Wiltshire Council Planning Consultation Response

Wiltshire Council Drainage Engineer
Technical Services Drainage Engineer
Wiltshire Council

Application No: PL/2024/05527 – Land South of Westwells Road, Westwells Road, Neston, SN13 9GB
Redevelopment of site to deliver extension to existing Spring Park data centre campus consisting of (a) free standing data centre building (b) energy, power, and water infrastructure (c) site access and internal roads (d) site security arrangements (e) diverted Public Rights of Ways (f) hard and soft, green and blue, landscaping and (g) other ancillary and auxiliary forms of development.

Figure 1: RoFSW Mapping – All Flood Depths

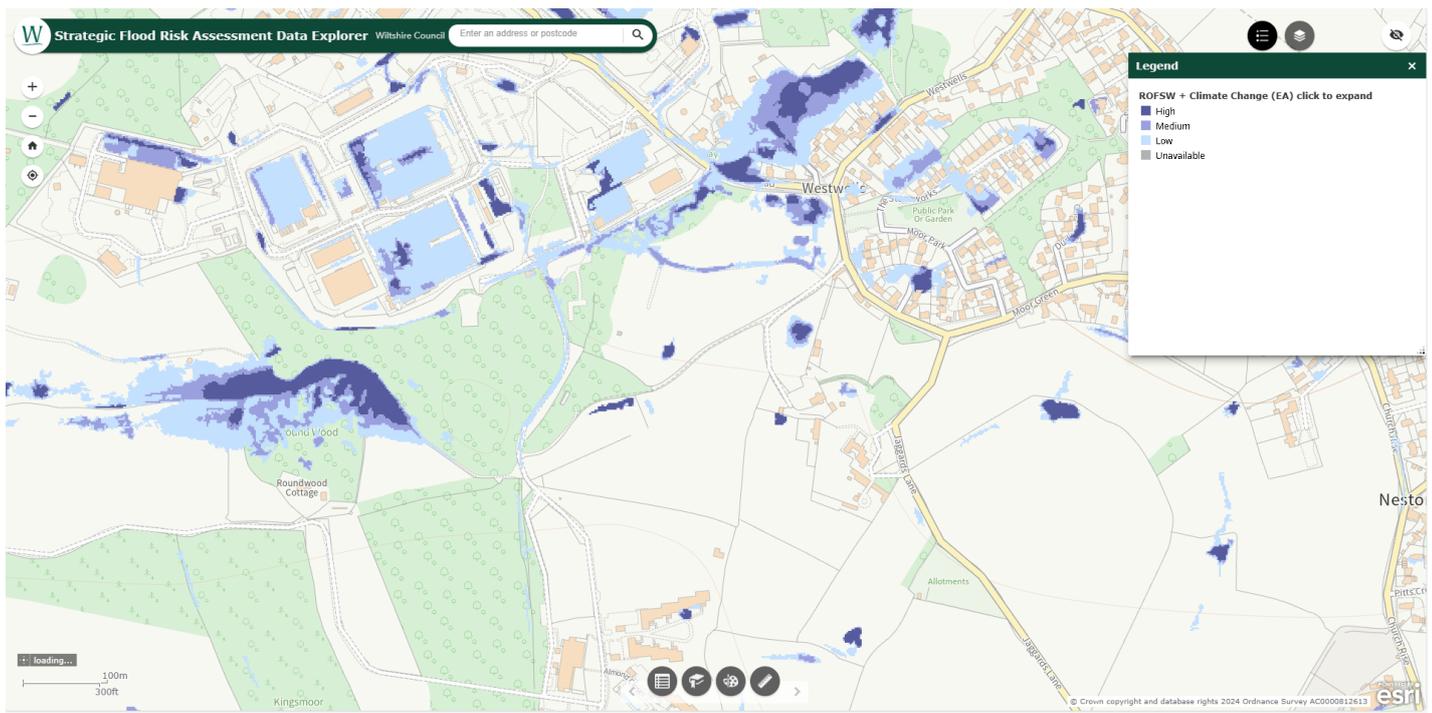
- The site is solely within Flood Zone 1 for Fluvial Flooding as demonstrated on the RoFRS maps.
- The site is identified to be at risk of Pluvial (surface water flooding) in a variety of events including the 1 in 30 yr (High), 1 in 100 yr (Medium) and 1 in 1000 yr (Low) return period events. It is noted based on the EA RoFSW Maps produced under the NAFRA2 dataset, that the majority of surface water flooding on site is predicted to be 0 – 200mm depth (see Figures 1 & 2 below).
- The site is identified within the SFRA to be unlikely to be at risk of groundwater flooding.

Figure 3: Natural overland flow paths with site indicated (red) and principle area of development within the site boundary (yellow)

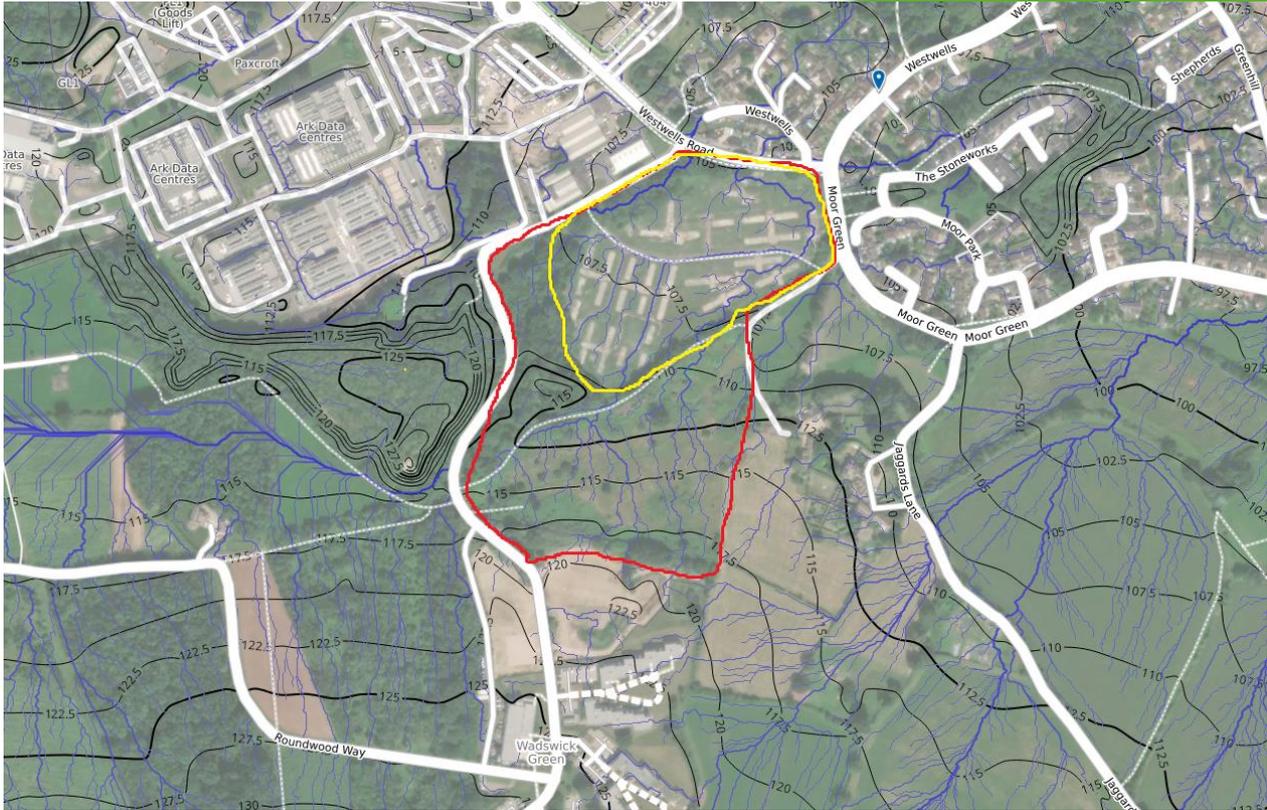
- The full site predominantly acts as a source of overland flow paths towards Westwells (Figure 3) – through appropriate controls and mitigations, including detailed consideration of overland exceedance flow routes, there is potential for the proposals to reduce downstream flood risk to Westwells.

- f. The applicant shall submit a plan showing overland exceedance routes for in excess of the 1 in 100 year plus climate change (40%) rainfall event, that minimise the risk to people and property. This shall include natural overland flow routes which originate off-site and enter within the red-line boundary of the development.

Figure 4: Natural flow paths of wider upstream catchment

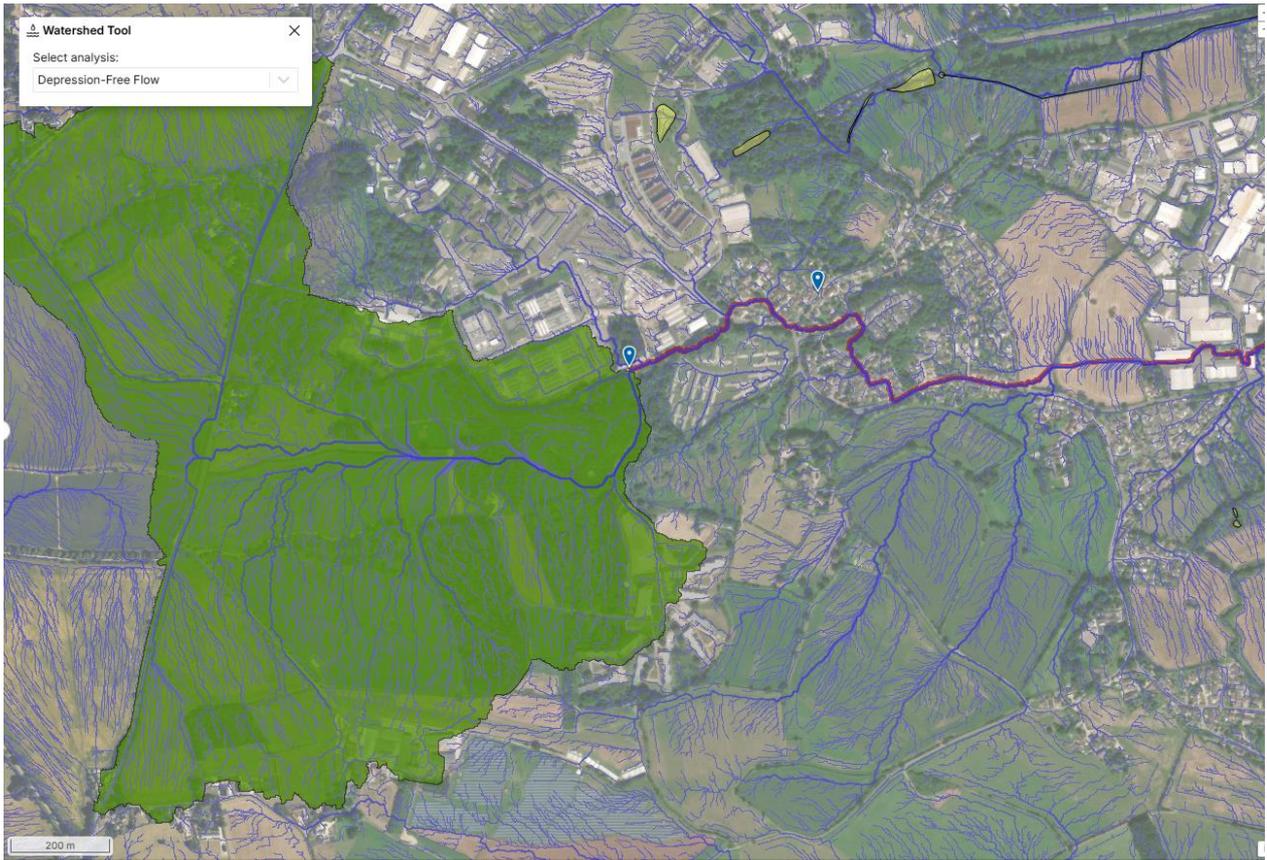
- There is a significant natural upstream catchment which may feed a natural overland flow path across the northern part of the site (Figure 4) adjacent to Rowan Lane. It appears from the applicant's current proposals that they will not be interrupting this flow path / creating increased detriment from the current case however this can be confirmed by the applicant through additional 2d hydraulic modelling of the site and surrounding area. It should be noted that the applicant is not obligated to resolve this natural flow path that directs towards Westwells, just not increase flood risk as a result of the planned development.
